AGENDA PLANNING COMMISSION MEETING MAPLE PLAIN CITY HALL September 04, 2025 6:00 PM

Request for Site Plan Review and a Conditional Use Permit to Allow a Cannabis Cultivation and Maufcacturing Business to Operate Within the Existing Building Located at 5600 Pioneer Creek Drive

Request by North Shore Gymnastics for Site Plan Review, Preliminary and Final Plat to Allow a New Building and Associated Site Plan Improvments for the Properties Located at 5380 and 5480 Pioneer Creek Drive

- 1. Application
- 2. Building Floor Plan
- 3. City Review Letter and Applicant Response

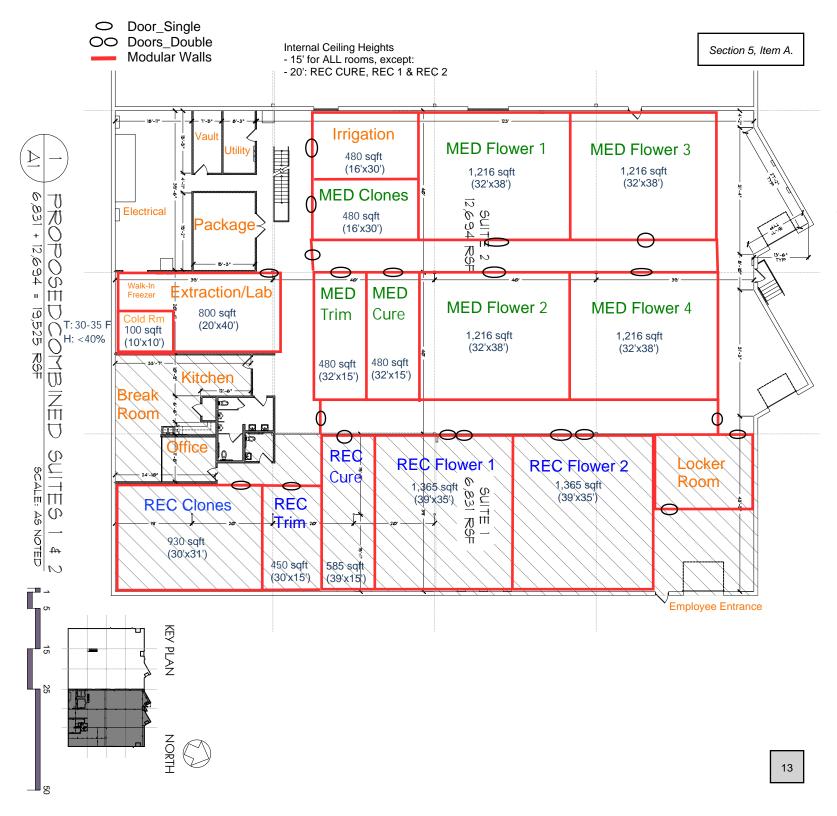
- Floor plan of proposed interior space with types of uses identified (i.e., total square footage of the lease area, breakdown of the manufacturing, warehouse and office spaces).

- Please see attached Floor Plan.
- O Describe or provide additional information that would describe any proposed interior building changes that are unique to your proposed use.

- There are very few interior structural changes needed to begin oper Section 5, Item A. other than plumbing; commercial grade sinks in the lab and the addition or floor drains in the warehouse. All modular structures on the attached floor plan are removable; i.e., not secured to the building or floor.
